QUESTION 110.1

SSES-FSAR

**SUSQUEHANNA STEAM ELECTRIC STATION
UNITS 1 AND 2
FINAL SAFETY ANALYSIS REPORT**

FSAR REV. 46, 06/93

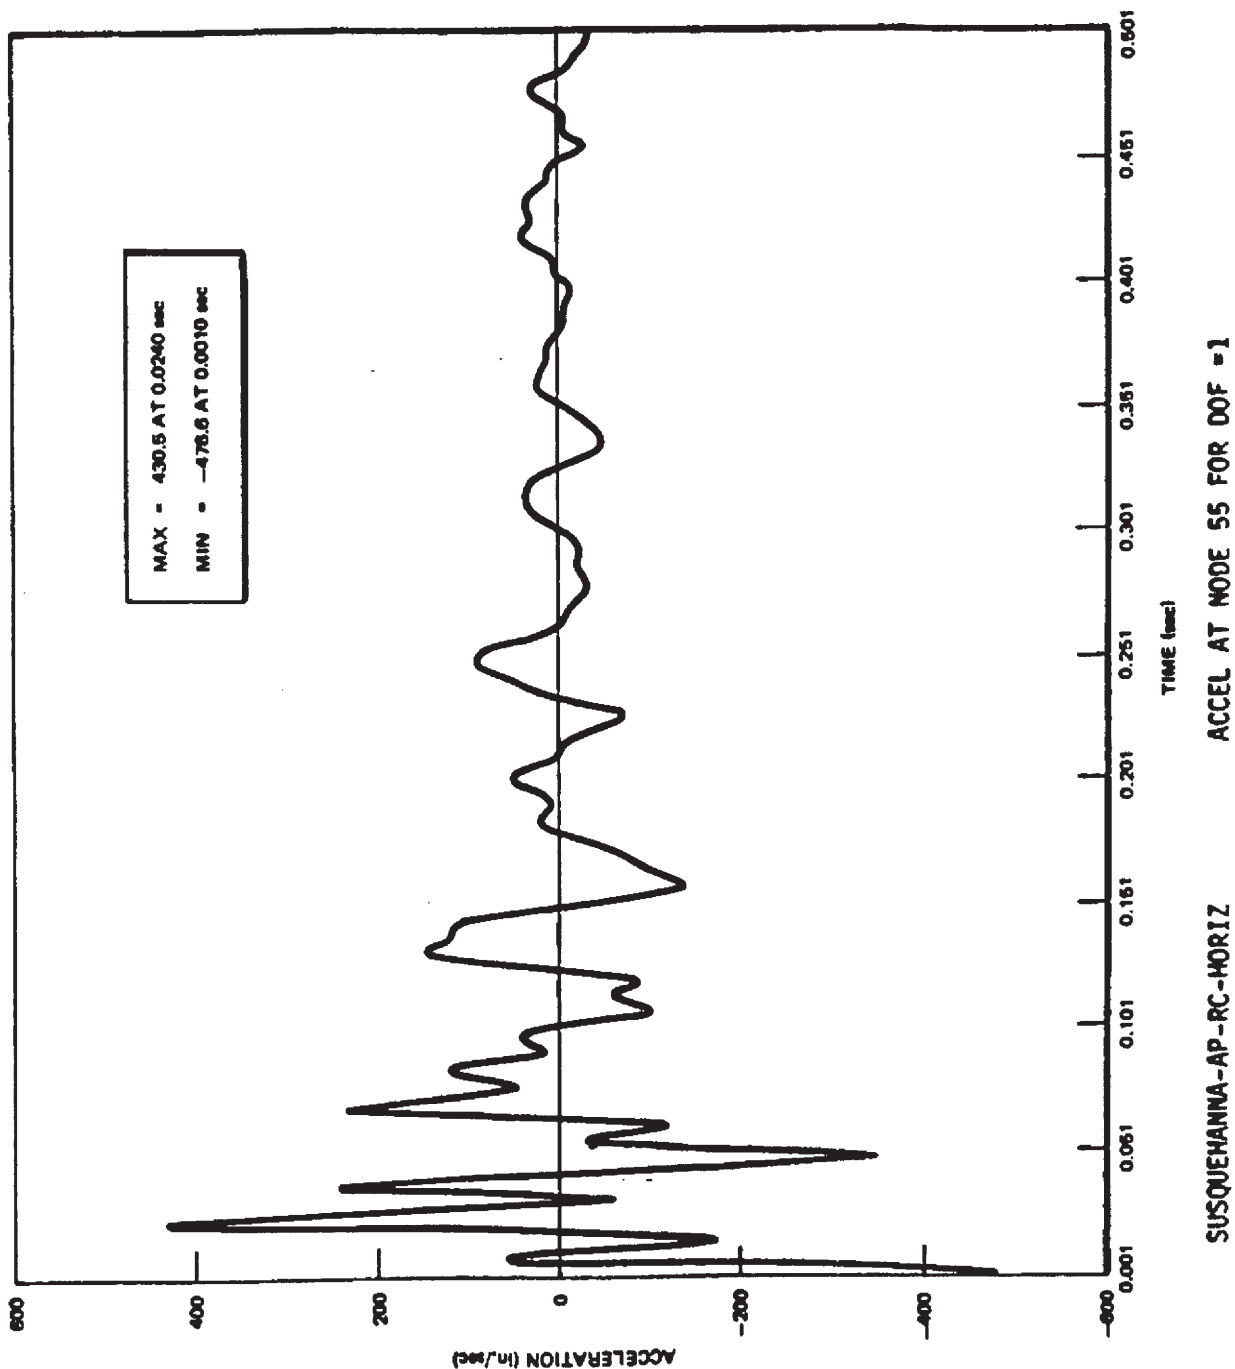
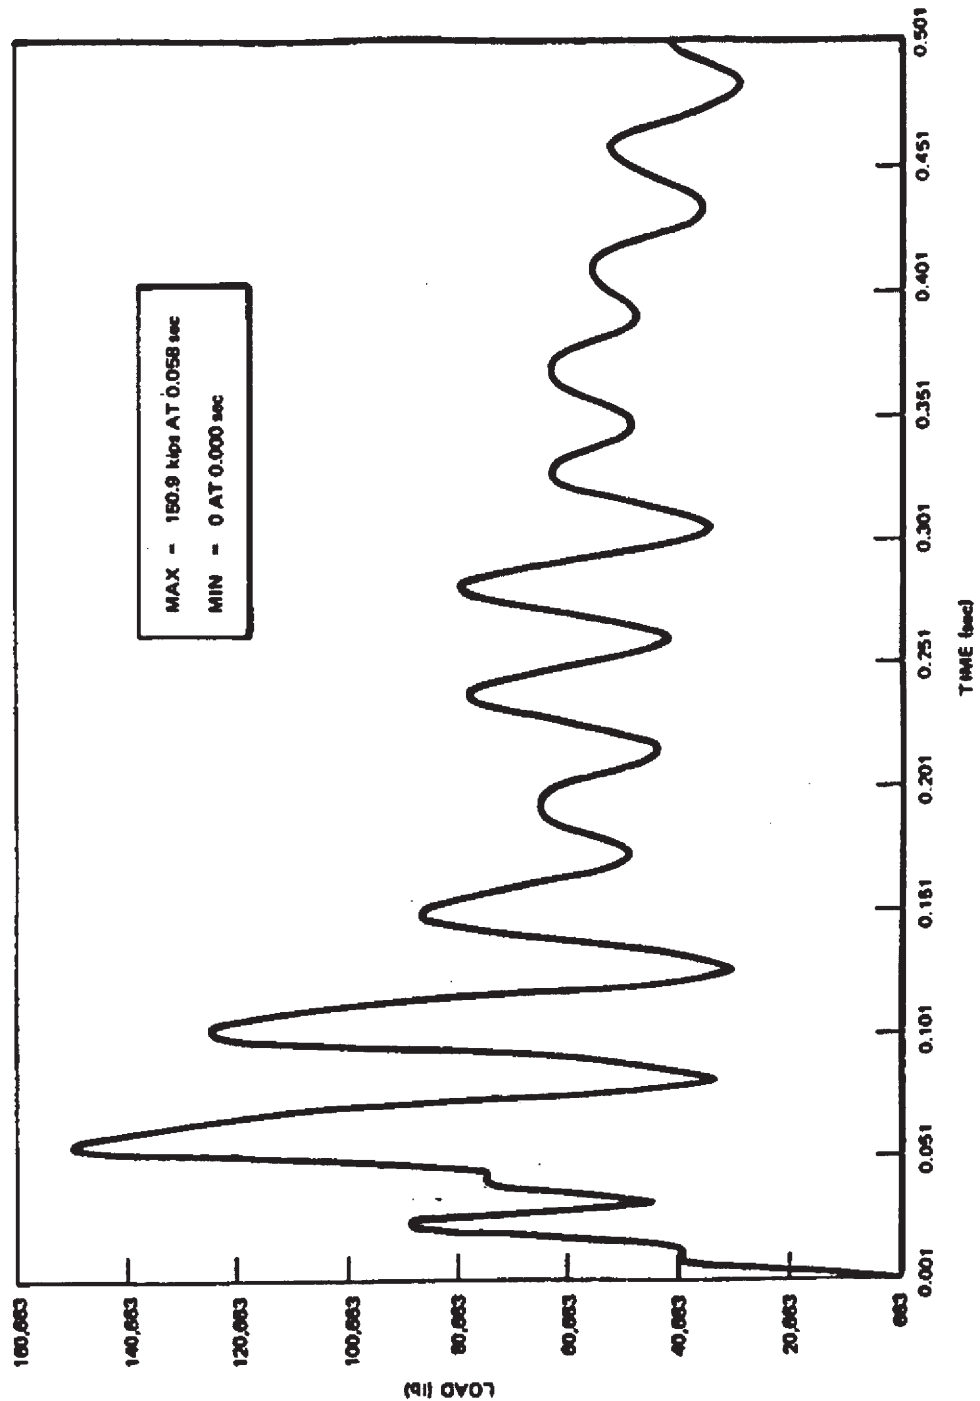
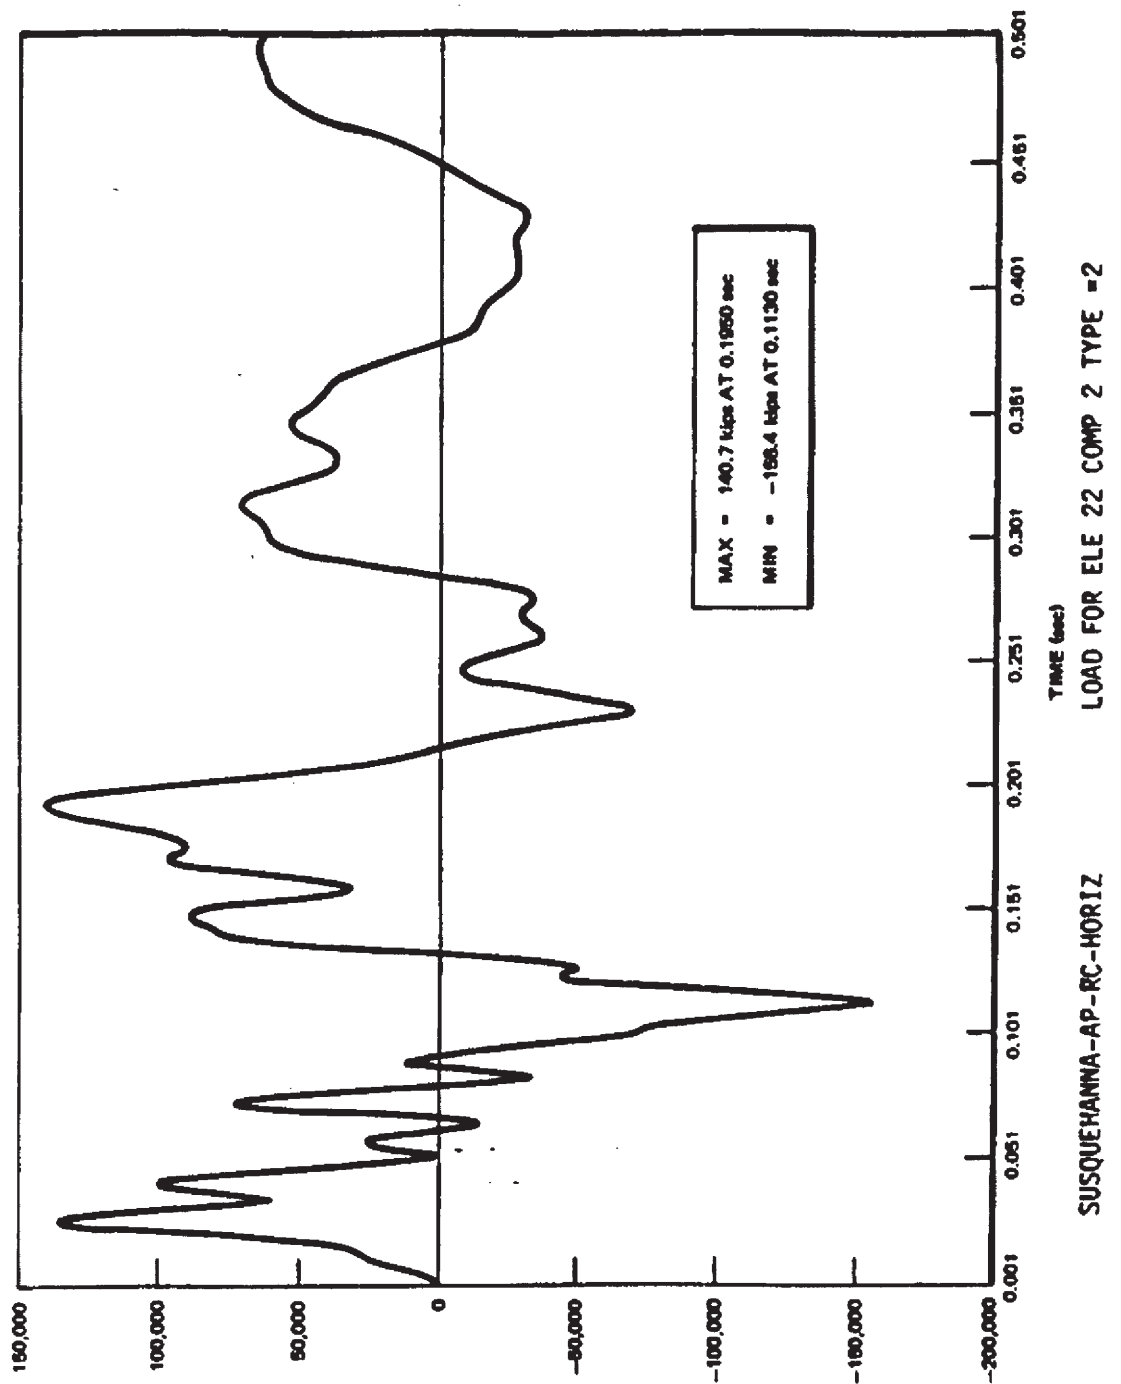
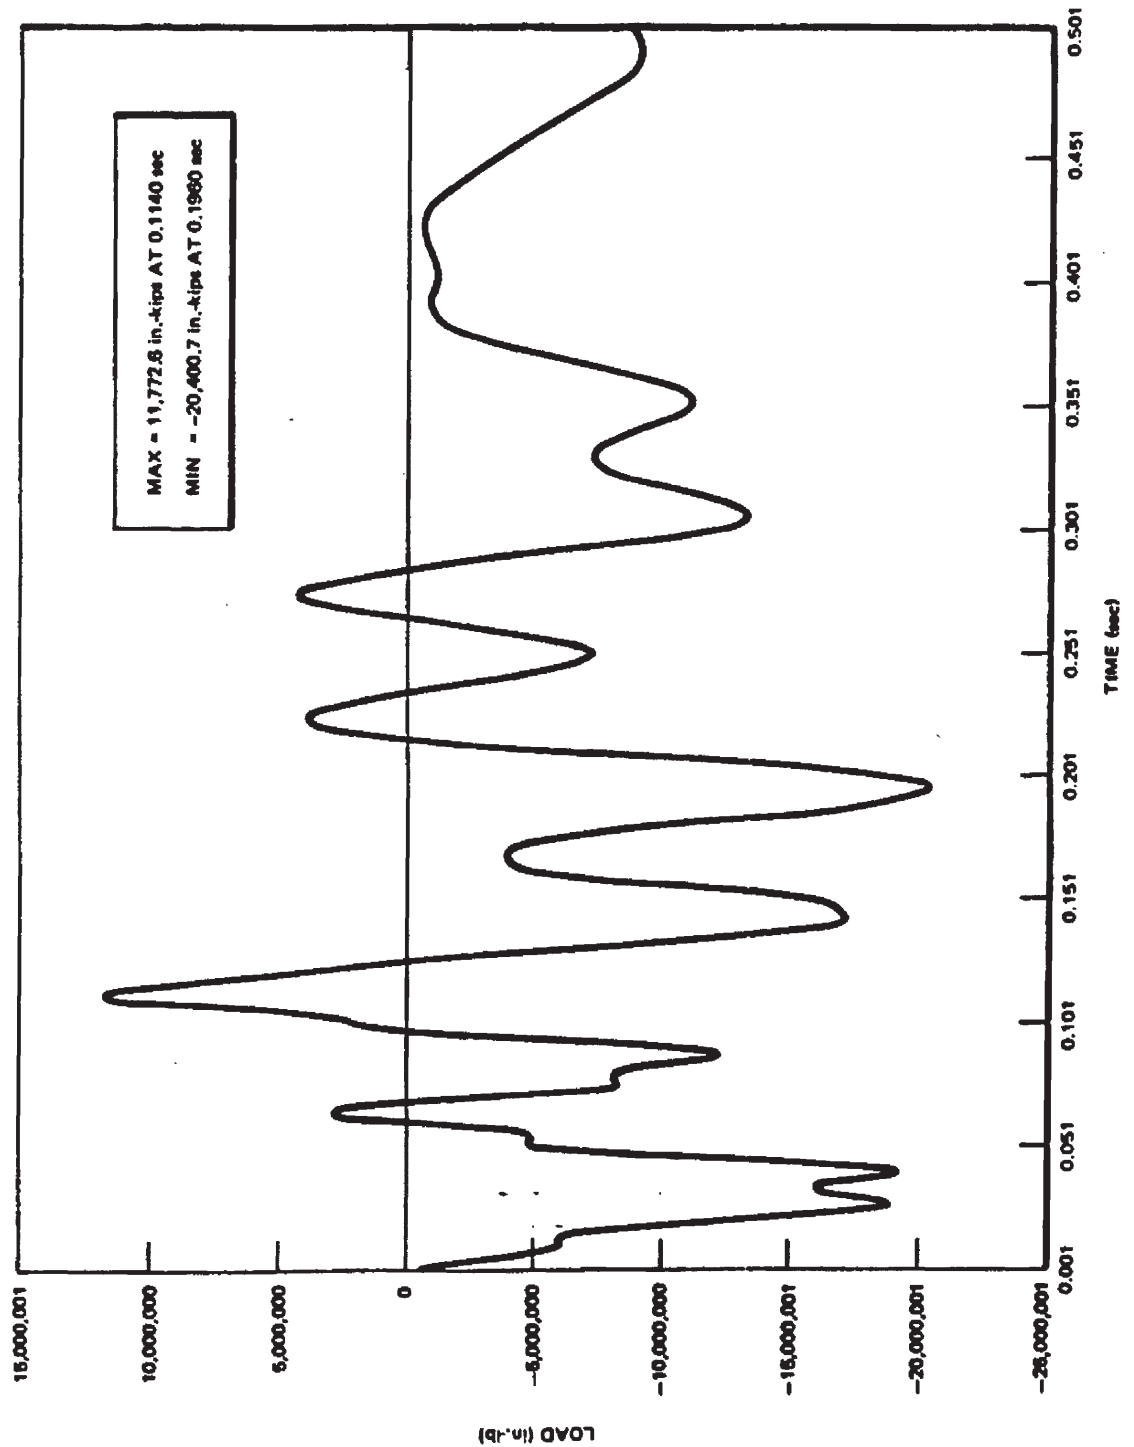
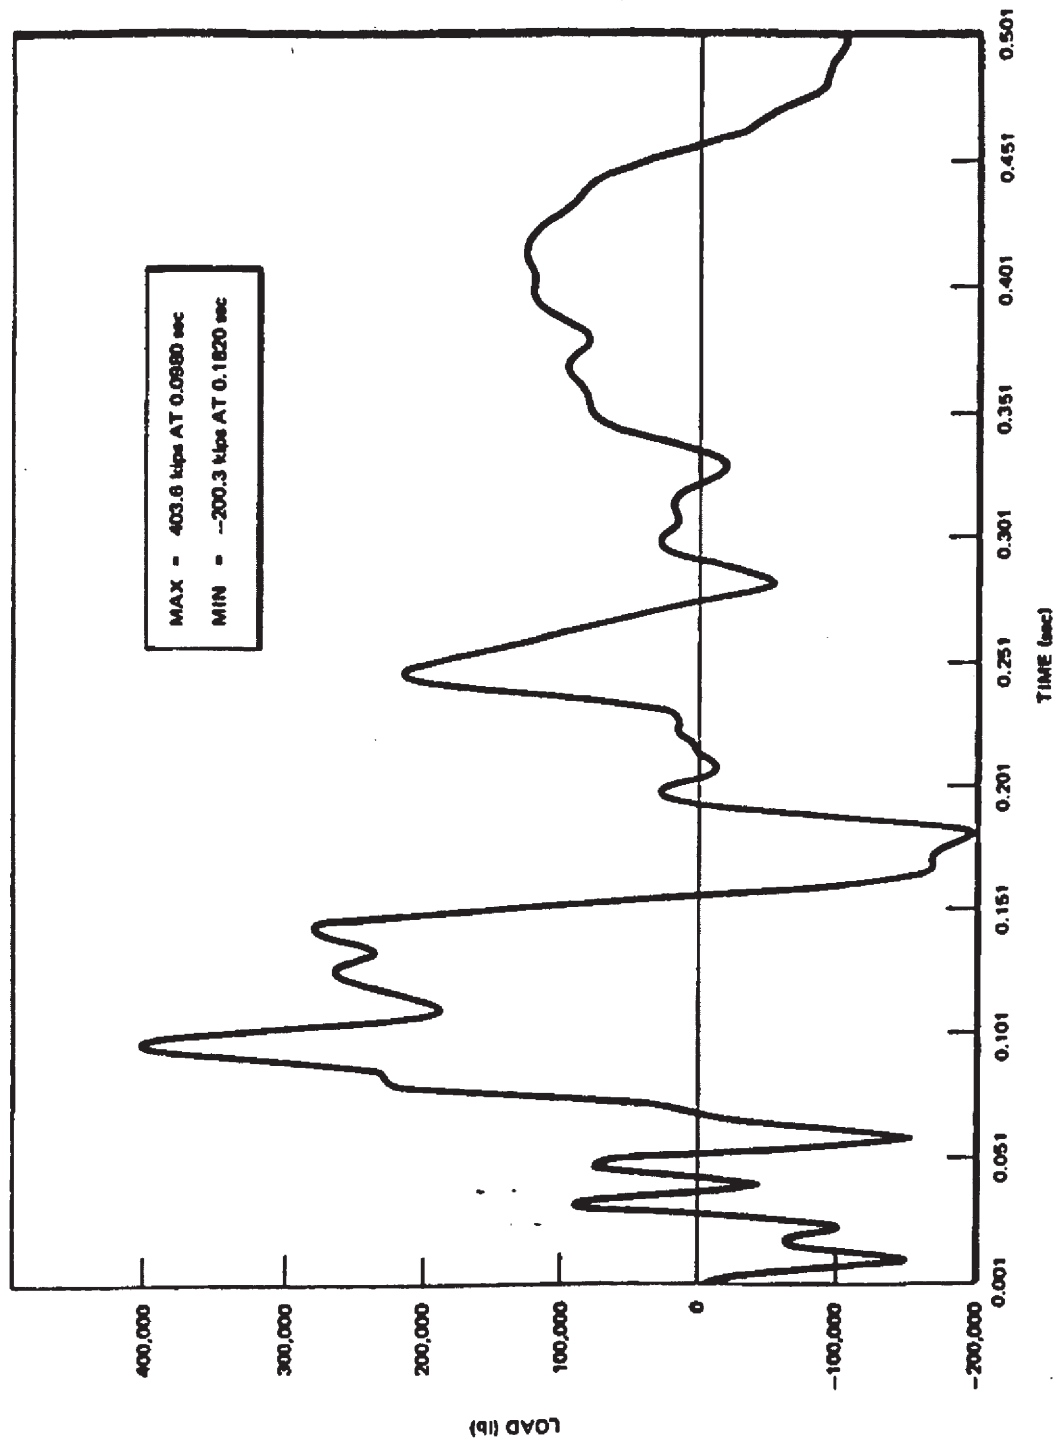
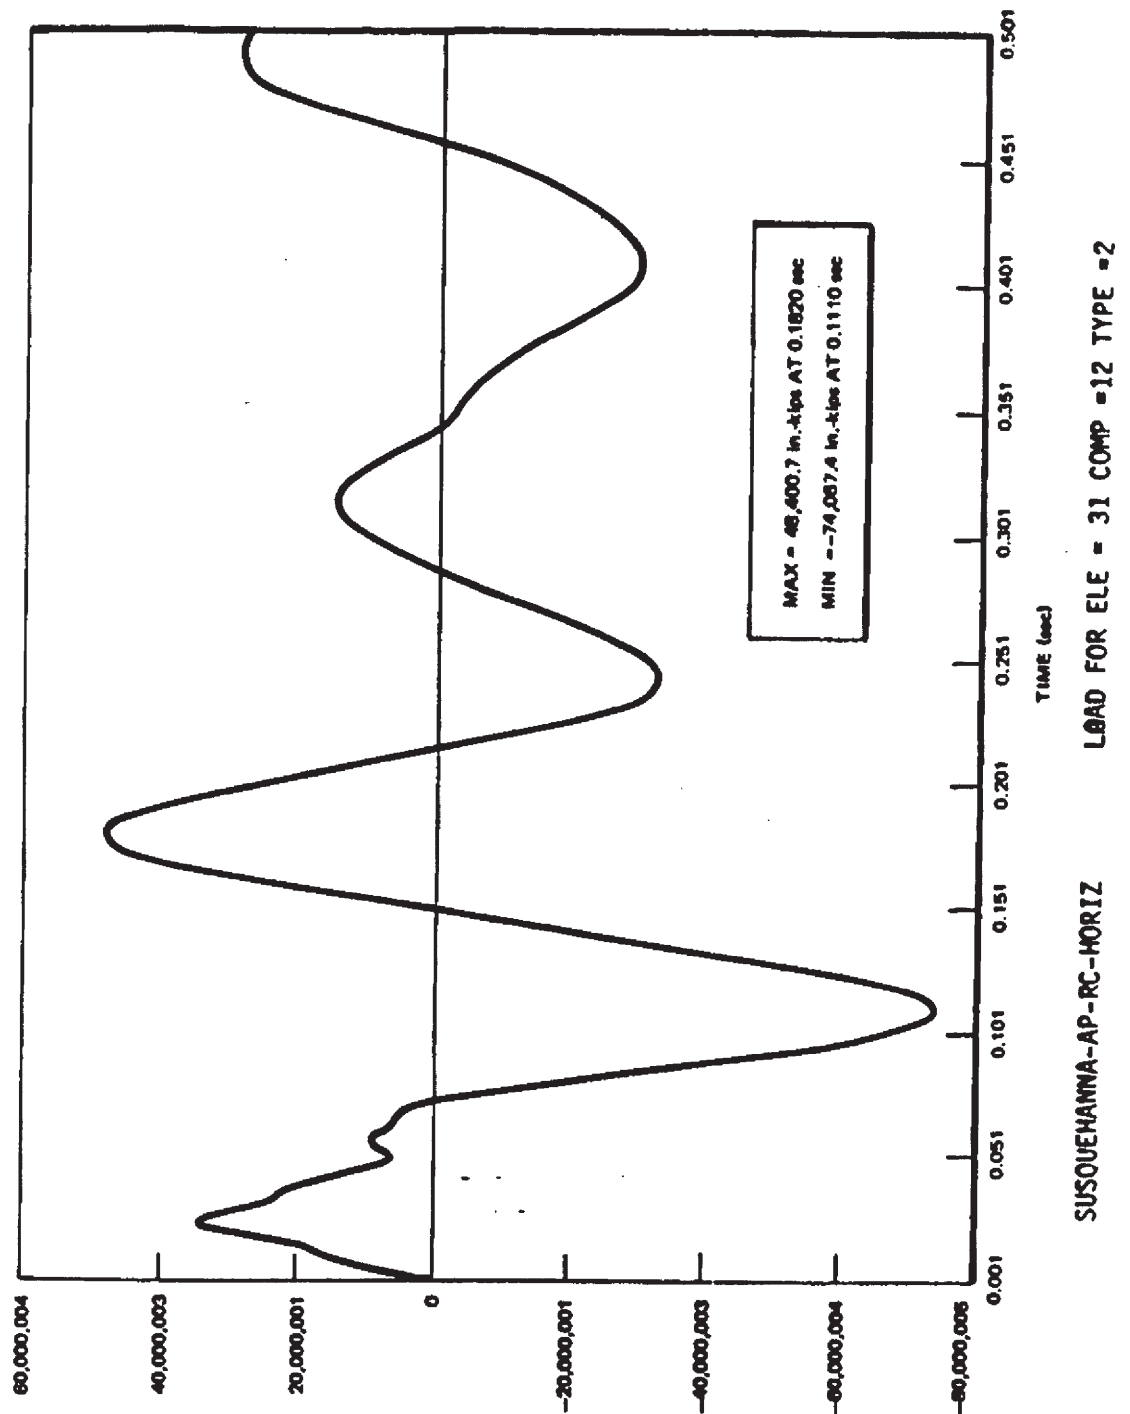
- a) Provide response time histories at one key location (having either the maximum stress combination or the most critical deflection combination, whichever is governing the design) for each of the following internal components:
 - (1) Jet pump
 - (2) Shroud wall
 - (3) Shroud head
 - (4) Control rod
 - (5) Instrumentation guide tube
 - (6) Core plate

For each location, separate response time histories for the various load effects associated with the SSE and most severe pipe break event should be provided.

- a) The following additional response time information for selected internal components under the SSE and the most severe pipe break accidents is provided.

Figures 110.41-3 thru 110.41-10 - Response time history plots due to horizontal SSE.

Figures 110.41-11 thru 110.11-16 - Response time history plots due to vertical SSE.

Figures 110.41-17 thru 110.41-24 - Response time history plots due to recirculation pipe break.

Figures 110.41-25 thru 110.41-32 - Response time history plots due to feedwater pipe break.

As for the pipe break events, we have considered both the feedwater line break and the recirculation line break. Judging from the response time histories, it is not conclusive as to which one is governing. Hence, we have included both sets.
